European tyre and Rim
Technical Organization

Cost-Benefit Analysis by EMISIA

September 9th 2022

2. – Implementation timeline of scenario F

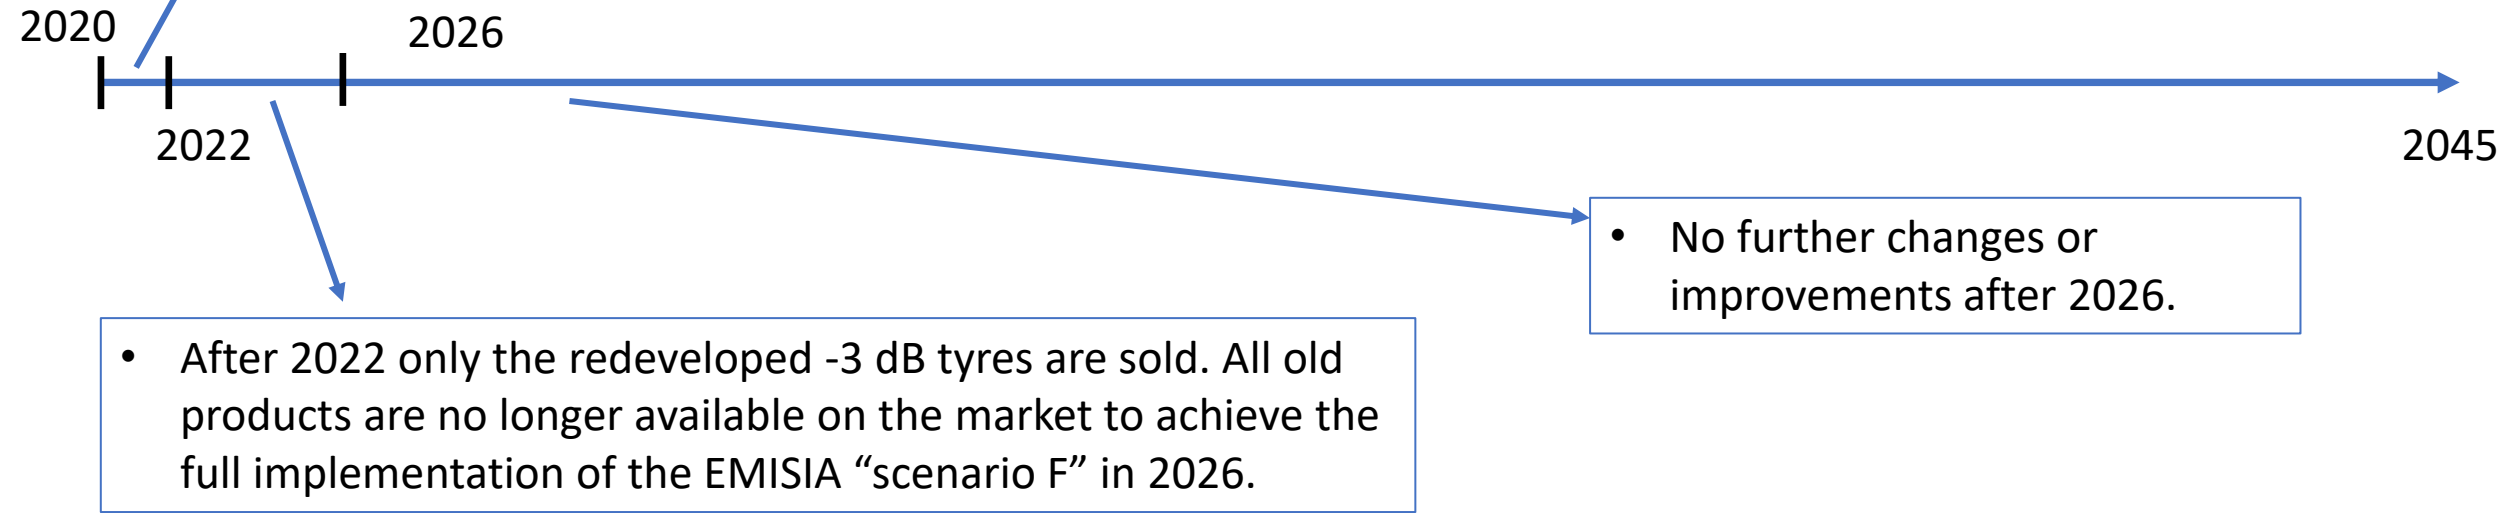
- The EMISIA study analyzed a time frame of 25 years, from 2020 to 2045.
- *Therefore, 3 dB tighter tyre noise limits for all three tyre label categories are used as a possible scenario to identify the possibilities and effects of such a noise reduction measure, **starting in 2022.***
- *With the average lifetime of a tyre between 3 – 4 years, this reduction should be **fully implemented in 2026.***

- With the average lifetime of a tyre between 3 – 4 years, this reduction should be fully implemented in 2026.

The timing designed by EMISIA would mean that:

- Within two years tyre industry redevelops around 91 % of all articles on the market (including C2 and C3) to become A-label tyres in noise without compromising other performances.
 - **91% of the market is redeveloped, all existing molds are replaced, the new tyres are tested, successfully homologated without further development loops and introduced to the market within two years.**

- **For ETRTO this timeline is unrealistic and one of the main reasons why the scenario on quieter tyres shows such a high benefit in the EMISIA study.**
